## MEMORANDUM

SUBJECT: Rock Creek Mine Closure Plan – Supplement to Phase 1 Construction

The purpose of this memo is to provide clarification and supplemental design information to the Area 3 Tailings Storage Facility (TSF) Dam breach concept described under Phase 1 closure construction activities. The plan to close the Rock Creek Mine has been developed by Tetra Tech (Tt) and submitted to the State of Alaska (State) for review on Oct. 24, 2011.

Figure 1. Water Surface Profile of PMF through the Breach at Station 1620.

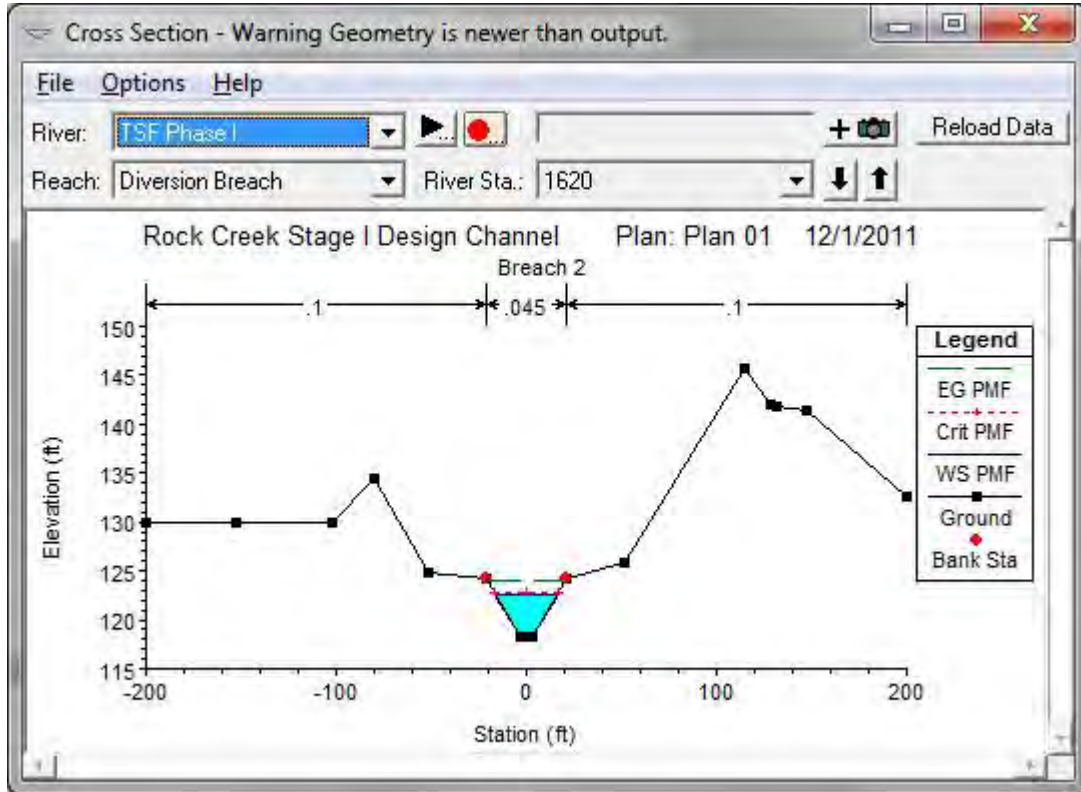
The hydraulics modeling shows that a PMF can safely convey through the breach section. Figure 1 shows a cross section and water surface profile of the PMF at Station 1620 in the middle of the breach. Table 3 shows tabular results for velocity, water surface grades, energy grades, and critical versus non-critical flow (i.e. Froude number). An evaluation of the Froude number for these stations show that flow ranges between non-critical and critical through this section, but flow is not substantially above 1.0 which is unity (i.e. Froude numbers less than 1 are non-critical flows, above 1 are critical flows). The maximum velocity at Station 1470 exiting the breach section is 11 feet per second (fps), acceptable for such a drastic event.

Figure 2. Water surface profiles in the tailings diversion ditch for the 10-year 24-hour and 100-year 24-hour storm events.

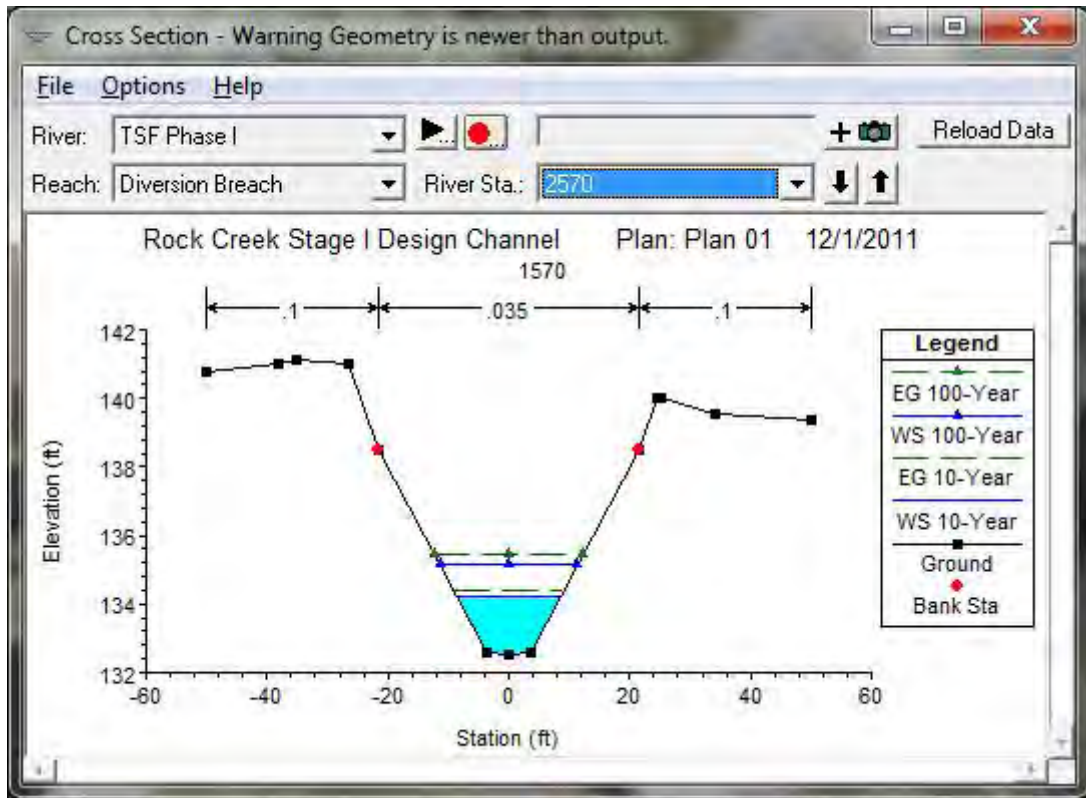
The hydraulics modeling for the 10-year 24-hour and 100-year 24-hour storm events show that flows adequately convey through the designed diversion channel around the covered tailings, through the breach channel invert, and through DC-3. Figure 2 and Figure 3 show water surface profiles for modeled stations in the tailings diversion ditch and in DC-3, respectively. While in some sections below the breach, DC-3 shows near bank-full conditions for the 100 year storm event, the channel appears to contain the combined flows from the breach and those occurring above DC-3. Table 4 shows tabular results for velocity, water surface grades, energy grades, and critical versus non-critical flow.

**FIGURE 10B**

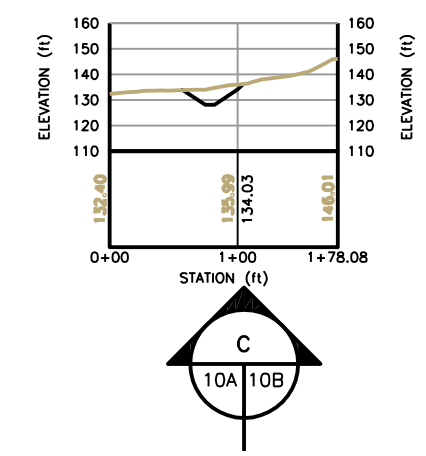
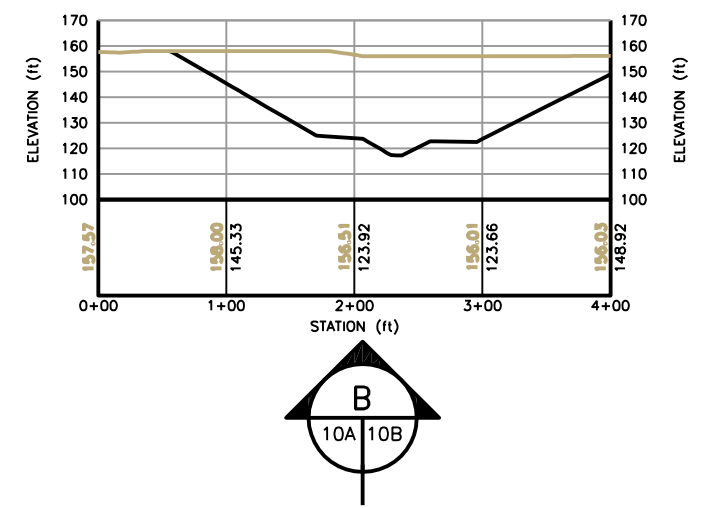
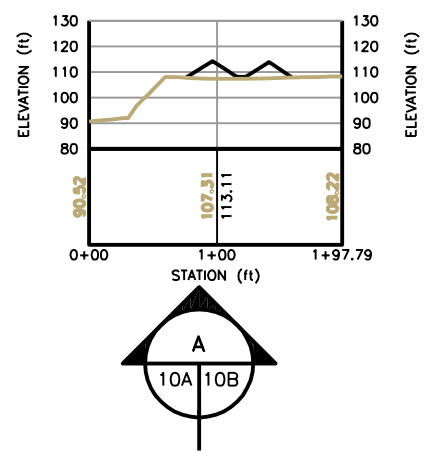
The breach route has been refined beginning near the lowest point inside the TSF by turning it southward to avoid the main sump upon exit. In order to enhance stability of the downstream ditch over time, the breach exit and ditch route are now located south of the main sump and away from the eventual fill that will be placed in the sump.

**FIGURE 10C**

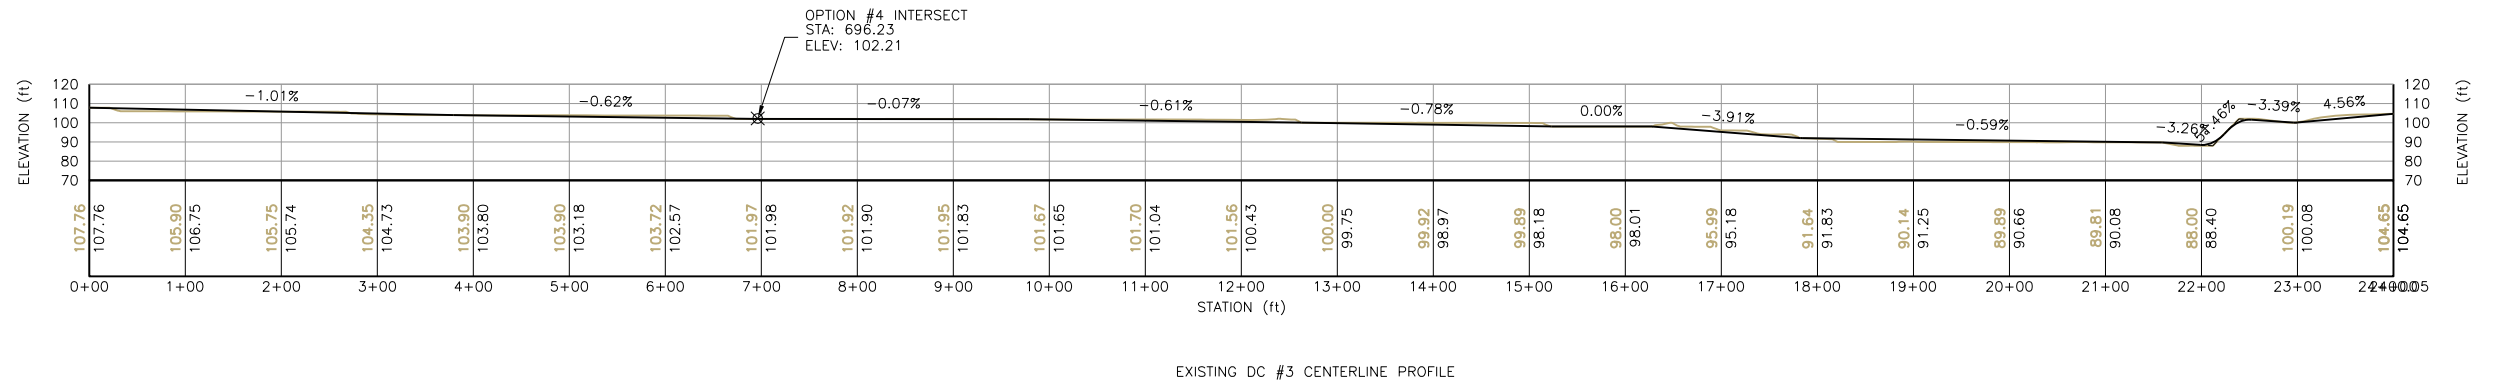
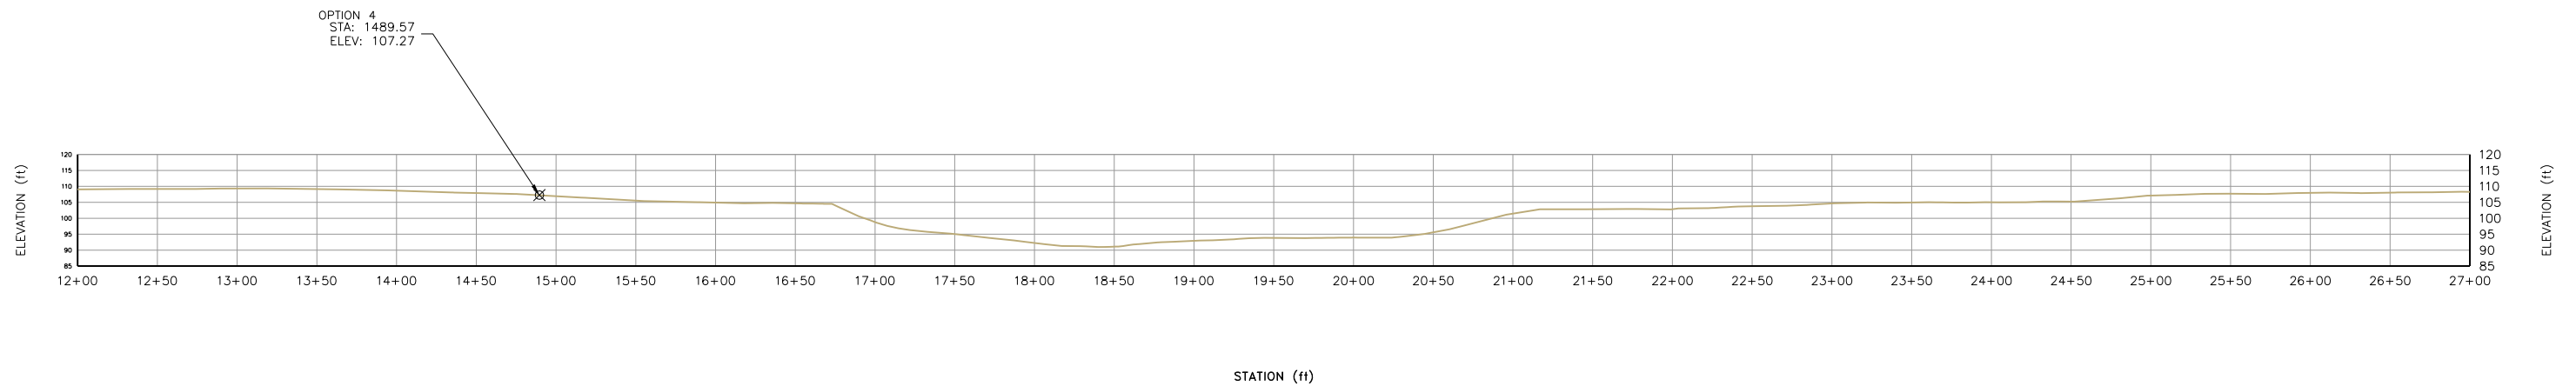
The south leg is currently drained by a lateral connection to the south sump. This pipe lateral will remain in place, but the sump pump will be removed and piping decommissioned. The south leg collection piping will be intercepted at the breach and diverted into the new drainage ditch between the dam and DC-3. The accompanying Figure 10A indicates that the toe drain flowline elevation at the center of the breach is 107.5 ft. The ditch intercept with DC-3 is approximately 102.6 ft, providing sufficient slope to daylight the pipe. These two outlets for the south leg will ensure gravity discharge both pre- and post-breach during the remaining winter months. The above-grade discharge from the drain intercept is expected to freeze up soon after the pipe construction is complete. However, the remaining drain to the south sump will provide a secondary route for collected water to be conveyed and remain below grade. The anticipated flow rate is expected to be low enough that the adjacent soils will allow infiltration without surface eruption and formation of aufeis.
